Land Use Final Decision

File number(s): DR 22-26 & VAR 22-15

Date of decision: July 27, 2023

Through a Design Review application type, the applicant proposed development through a building of 2,872 square feet (sq ft) with two drive-through lanes for a Chick-fil-A fast-food restaurant.

Exhibit D8 Sheet C5.1 Fire access plan excerpt

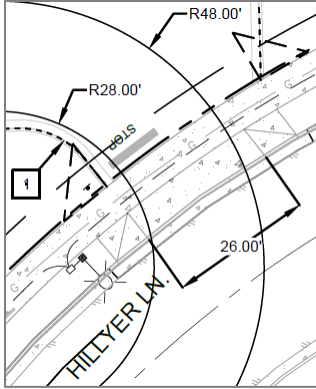
D8. Driveway max width: To conform with WDO Table 3.04A maximum regarding paved width of two-way driveways in a commercial context, the developer shall revise the site and composite utility plans – or equivalent sheets within a building permit application plan set through the Building Division and/or a civil engineering review application civil plan set through the PW Engineering Division – either to illustrate and dimension the approach, apron, curb cut, or ramp of the middle of the three driveways (Driveway 2) at 24 ft max width or to document if and how Table 3.04A footnote 7 about Woodburn Fire District OFC administration is applicable. For the latter, documentation shall include at least either (a) a letter or equivalent from the District or (b) revision of the fire access plan, which Exhibit D8 excerpts, to narrow the driveway to that necessary to accommodate the illustrated fire apparatus outside turning radius and to dimension the narrowed driveway apron. If through building permit review, then this is due prior to issuance, or if through civil engineering plan review, then due prior to ODOT or PW issuance of an approved civil plan set.

Exhibit D14

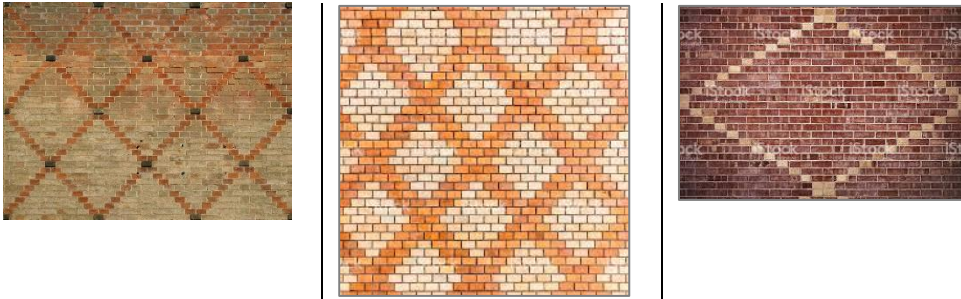
D14. Trash enclosure Architectural Wall: To conform with WDO 3.06.06B.6 & 7, the developer shall revise architectural sheets prior to building permit issuance, including to revise Sheet A-103 to add color and material legend information so that it would not be necessary to turn to Sheet A-301. Specifically:

- a. 3.06.06B.6 regarding having, “an earth tone coloration other than grey on at least eighty percent (80%) of the surface”: For both the grayscale and color elevations, either clarify that the bottom, larger area of color is not grey or revise to other than grey.
- b. 3.06.06B.7 regarding the wall being, “architecturally treated with scoring, texture, or pattern on at least eighty percent (80%) of the surface”: Brick itself is not texture, and default stretcher bond does not count as a pattern. Either use another brick bond, any of header stretcher, English, or Flemish, or in the bottom area that is the majority of wall area use two colors, with one laying out a diamond pattern similar to any of the examples that the exhibit below illustrates. Stucco would be acceptable as a means of texture.

PLANTING PLAN
 SHEET NUMBER

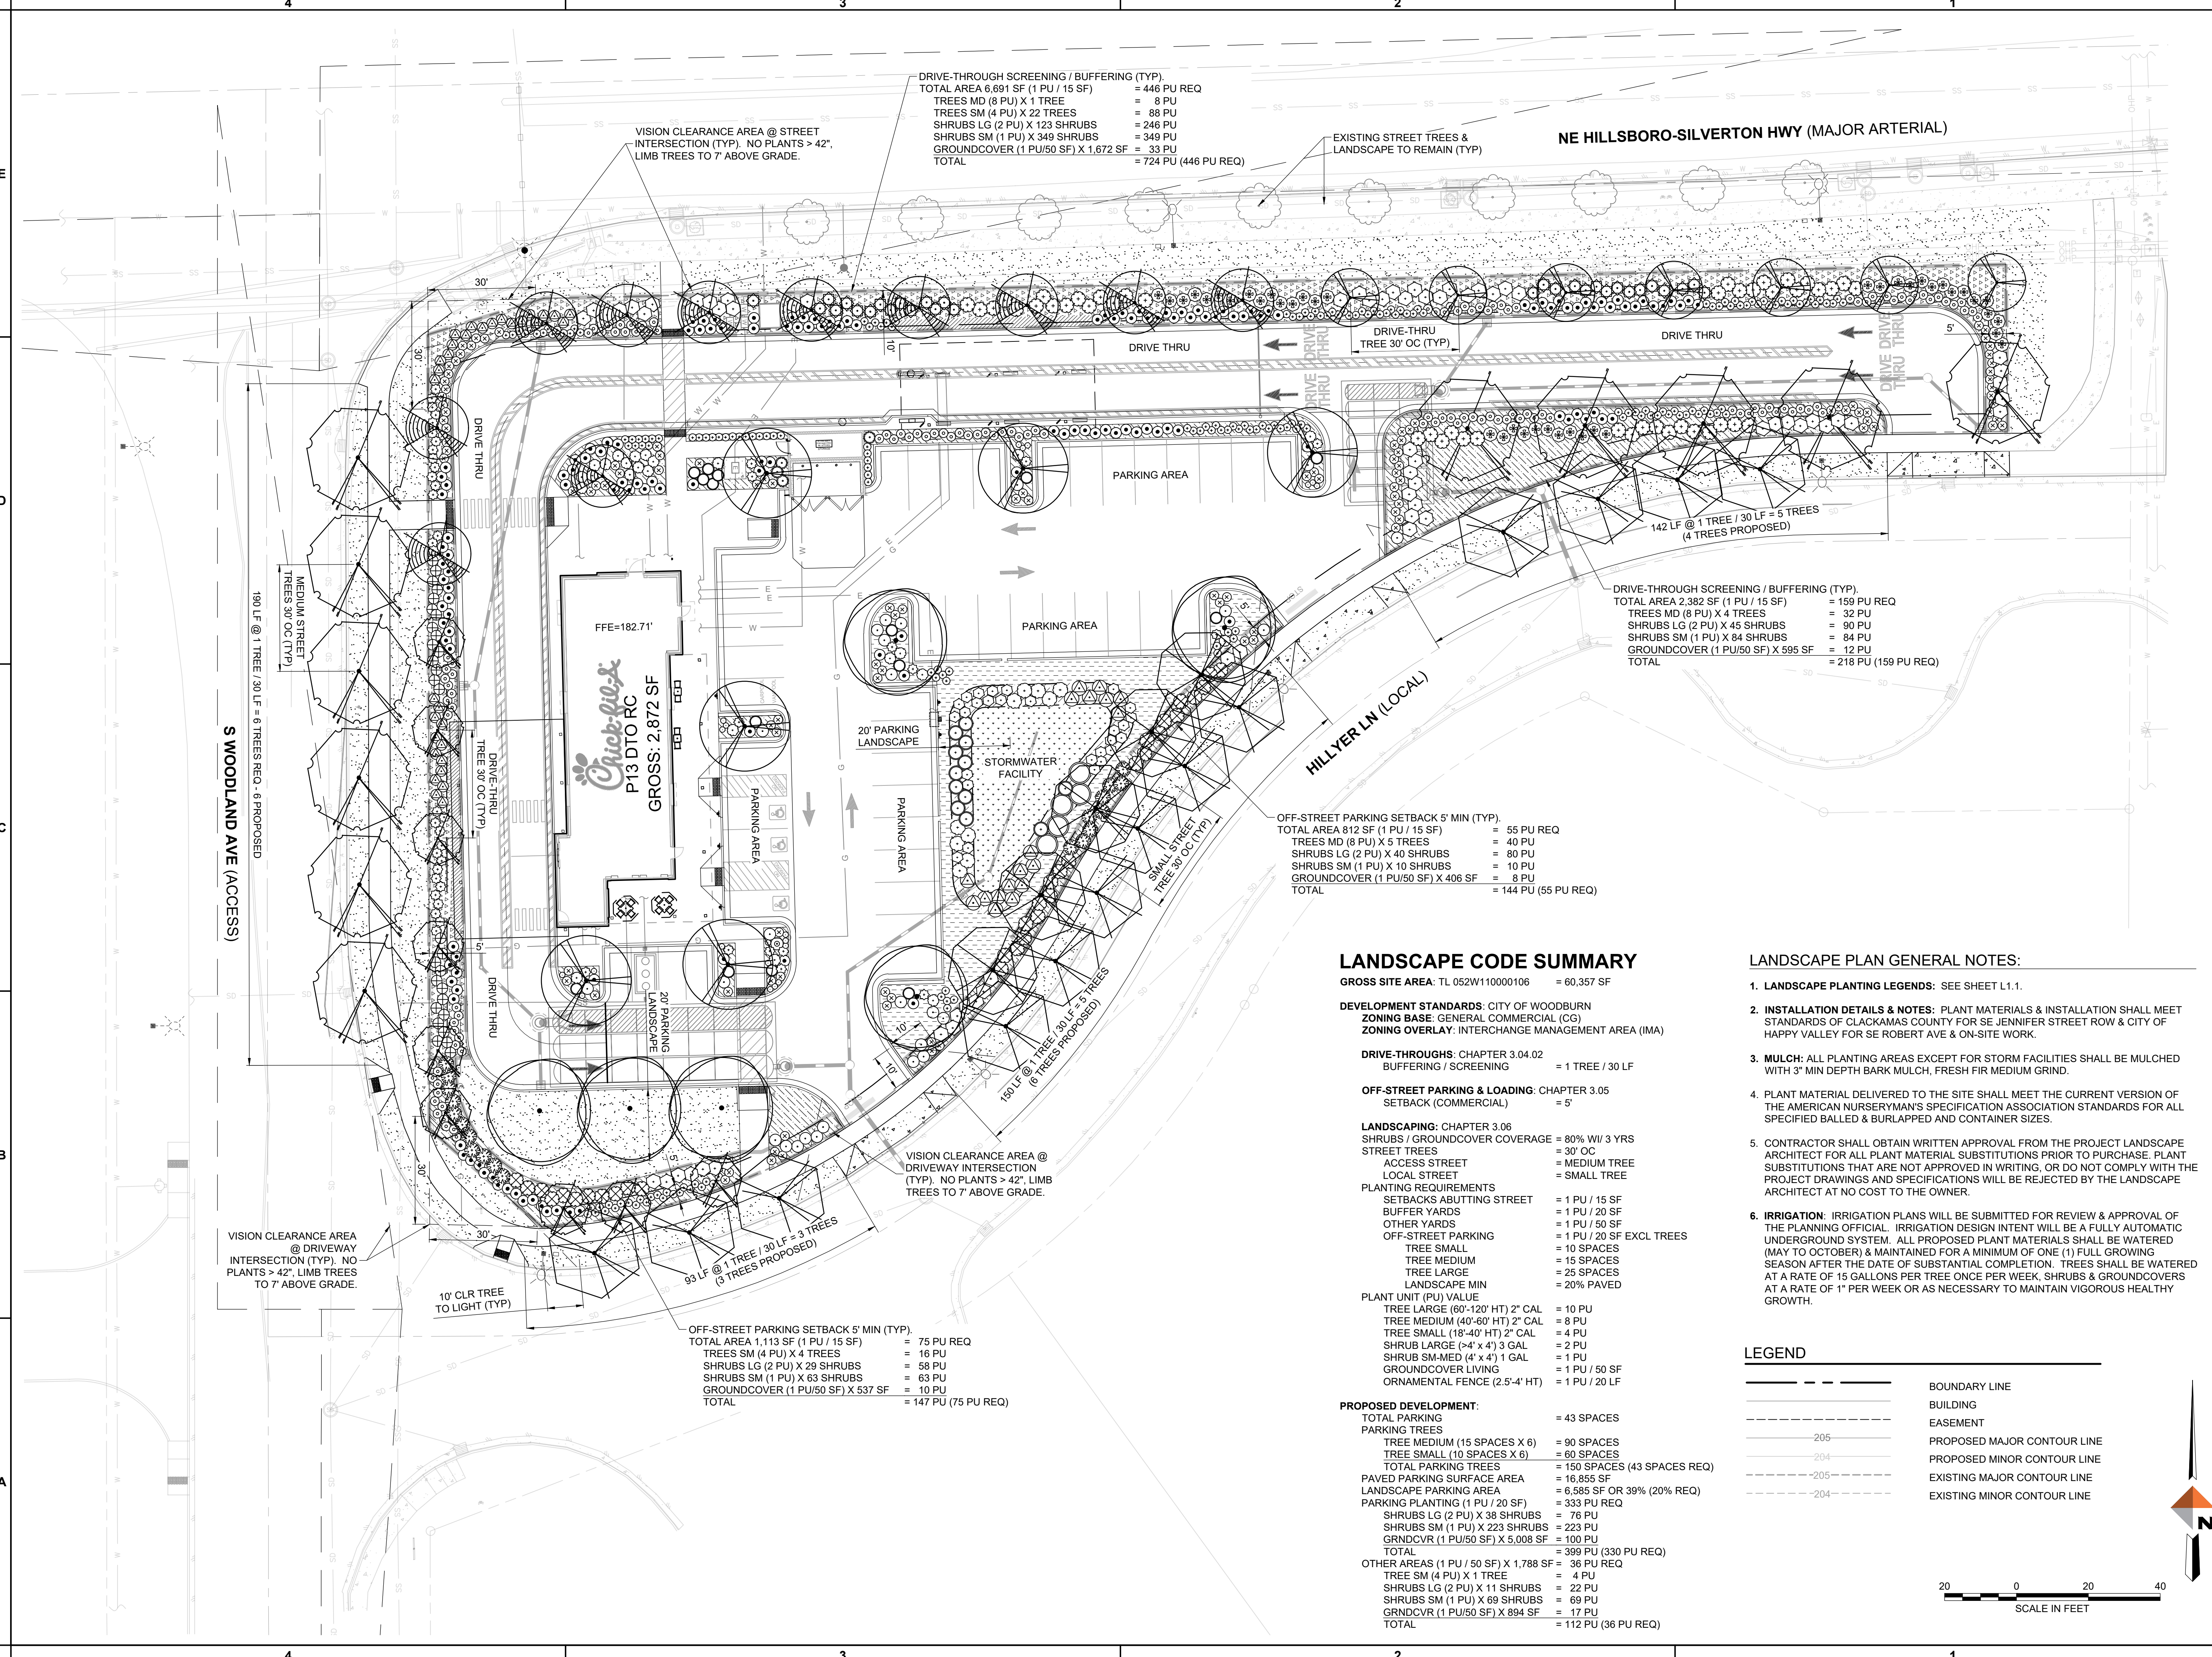
D12. Landscaping notes: To conform with WDO 3.06.02J, the developer shall revise landscape plan Sheet L1.0 general note 2 to correct jurisdictional references prior to building permit issuance.

D13. Walkway landscaped islands: To conform with WDO 3.06.03C.4, the developer shall revise site and landscape plans prior to building permit issuance and plant minimum area parking area landscaped islands at each of two drive aisle crossings of wide walkways:
